**ADDENDUM NO. 1
FEBRUARY 26TH, 2026**

PROJECT: ANSON ISD
ELEMENTARY & HIGH SCHOOL CLASSROOM ADDITION

BID DATE: MARCH 5TH, 2026

NO.	REVISION	DATE	PROJECT #	SCALE	SHEET
1	ADDENDUM 1	02-26-2026	25320	1/8" = 1'-0"	1A2.1

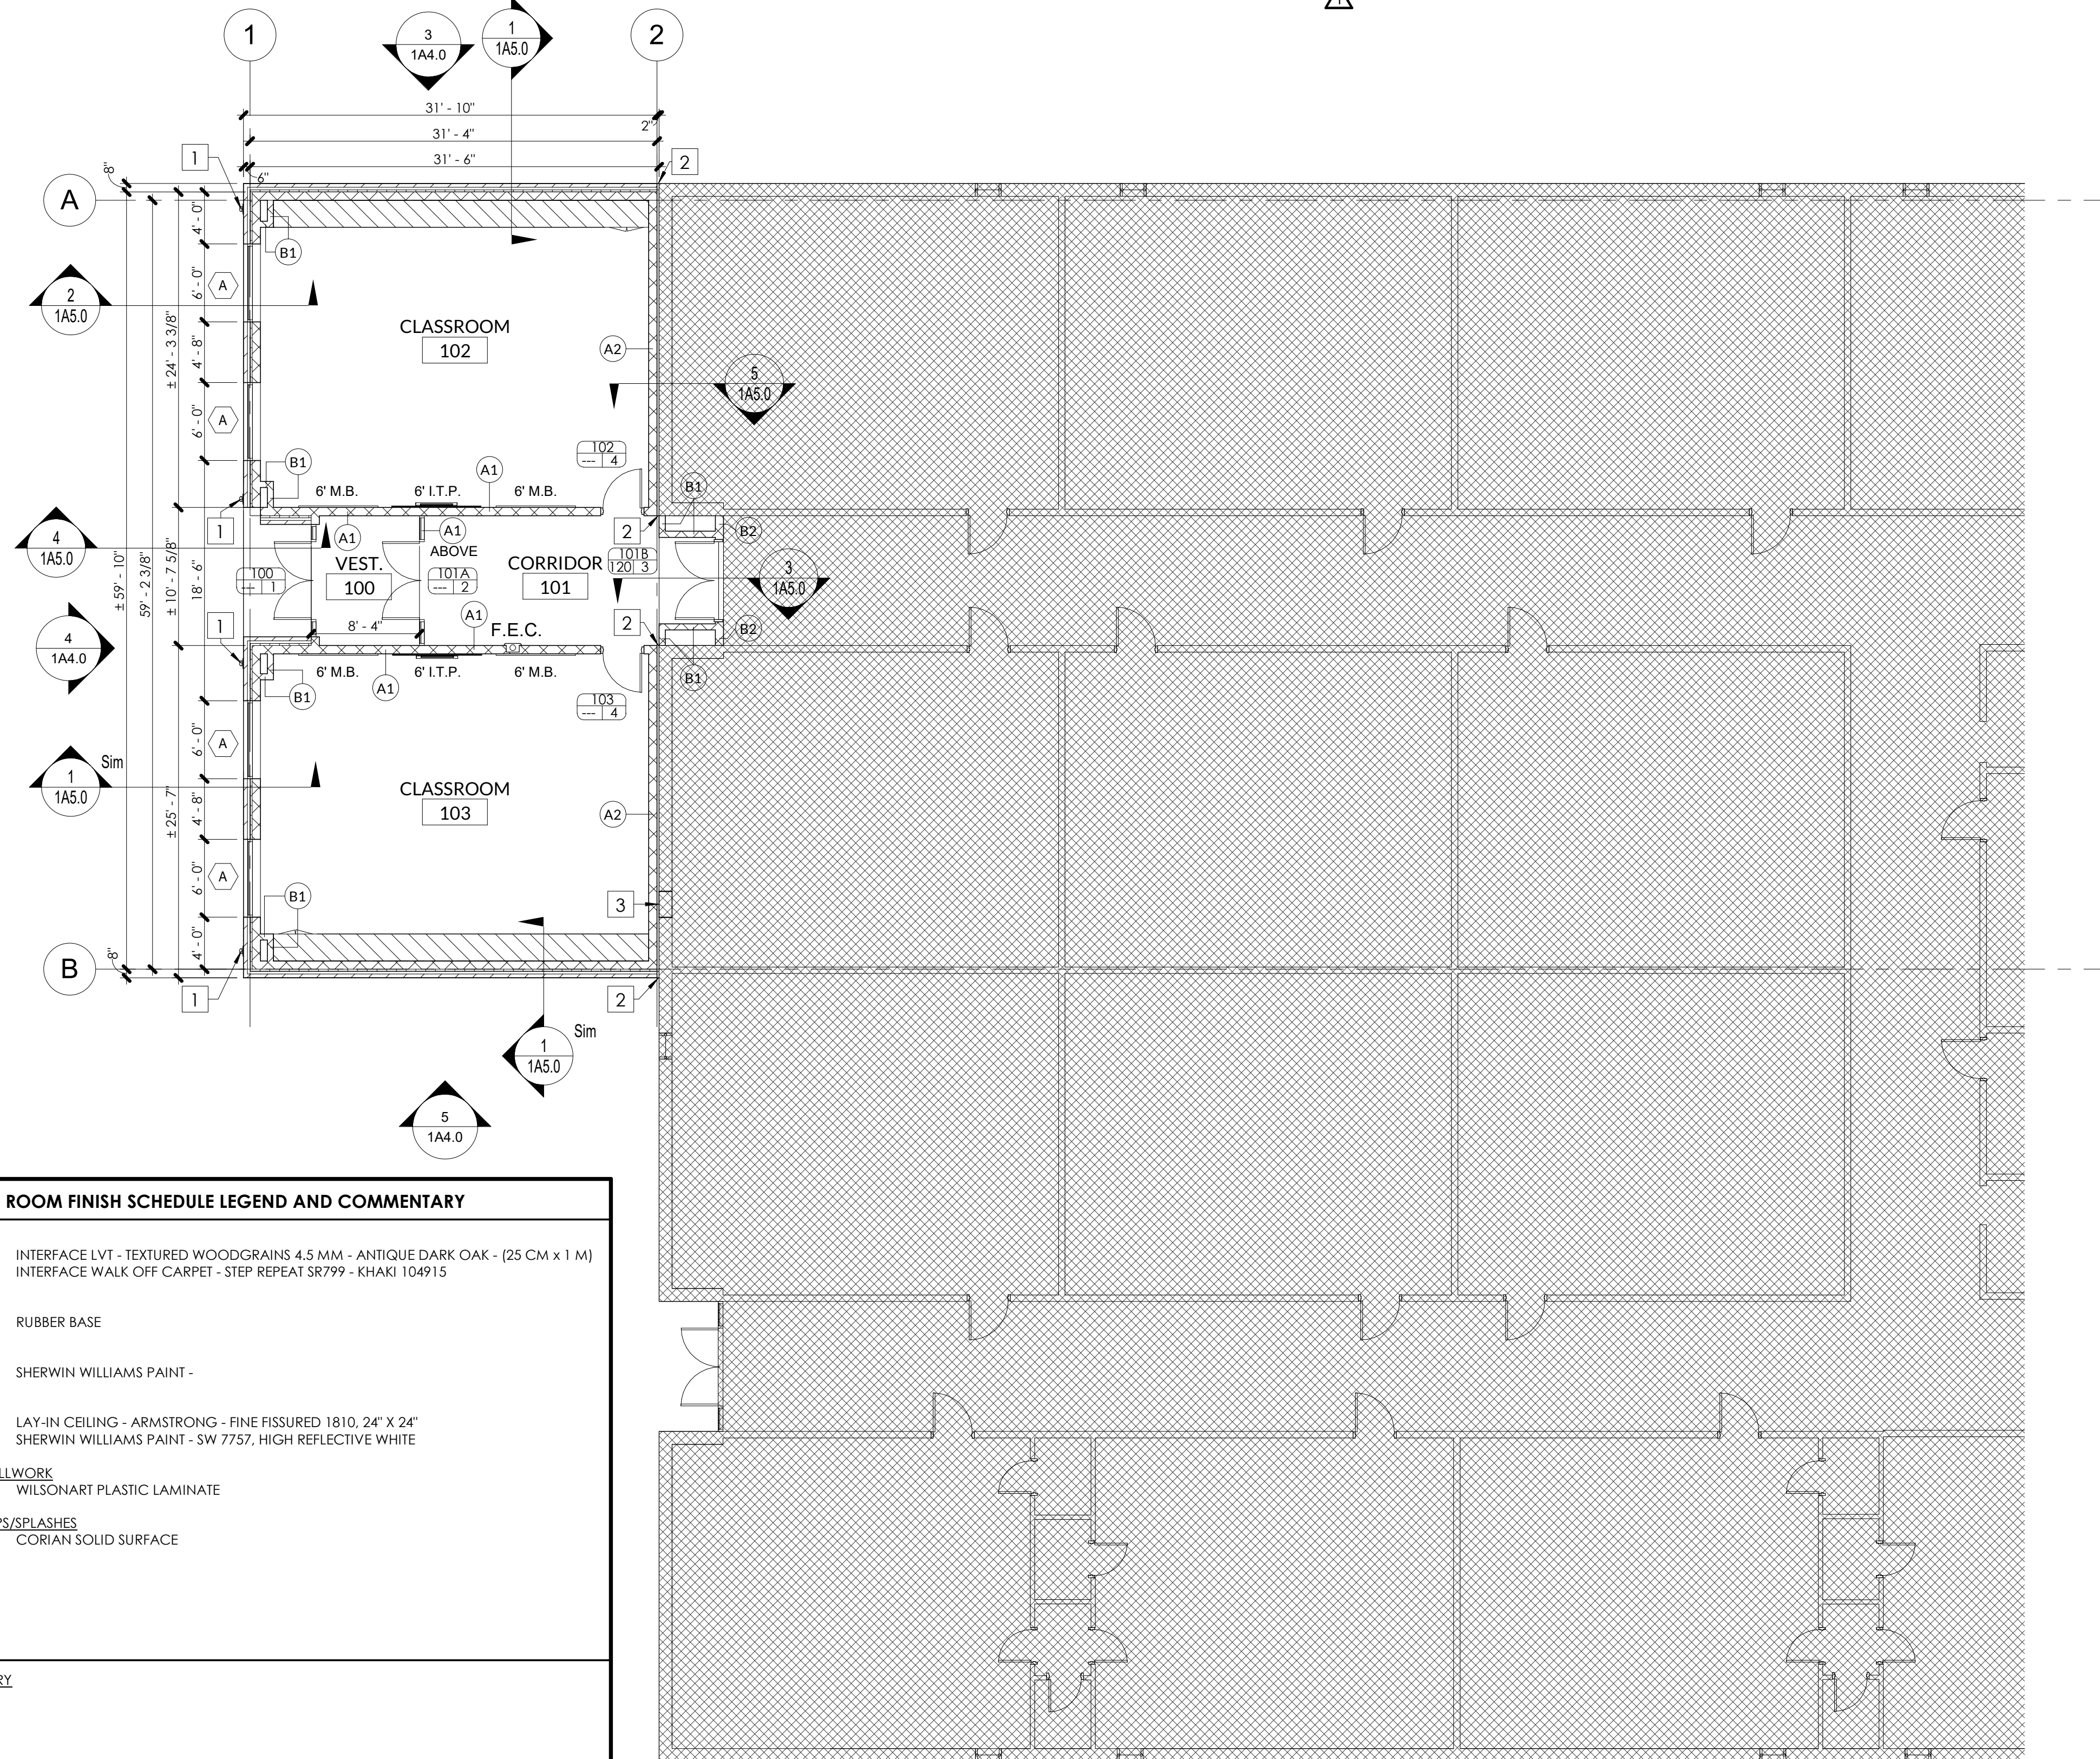
- Item #D1** **Sheet 1A2.1** – REPLACE sheet with attached sheet 1A2.1 dated 02-26-2026. UPDATED room finish schedule ceiling heights.
- Item #D2** **Sheet 1A5.0** – REPLACE sheet with attached sheet 1A5.0 dated 02-26-2026. UPDATED wall sections showing raised top of steel & lowered ceiling heights.
- Item #D3** **Sheet 1A7.0** – REPLACE sheet with attached sheet 1A7.0 dated 02-26-2026. UPDATED reflected ceiling plan with updated lighting layout in Vest. 100 & ceiling heights.
- Item #D4** **Sheet 1S1.0** – REPLACE sheet with attached sheet 1S1.0 dated 02-26-2026. UPDATED plan with missing non-load bearing CMU walls & added dimensions.
